Addendum 52 – UN Regulation No. 53

Revision 4 – Amendment 3

03 series of amendments – Date of entry into force: 29 May 2020

Uniform provisions concerning the approval of category L₃ vehicles with regard to the installation of lighting and light-signalling devices

Model A

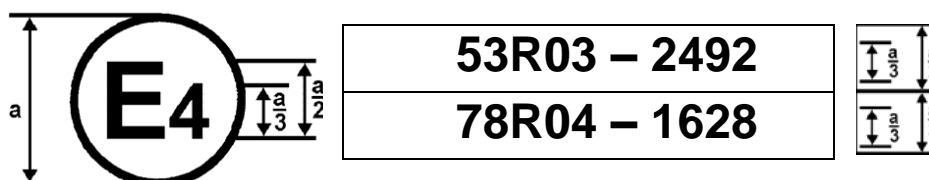
Annex 2, amend to read:

The above approval mark affixed to a motorcycle shows that the vehicle type concerned has, with regard to the installation of lighting and light-signalling devices, been

approved in the Netherlands (E 4), pursuant to UN Regulation No. 53, as amended by the 03 series of amendments. The approval number indicates that the approval was granted in accordance with the requirements of UN Regulation No. 53.
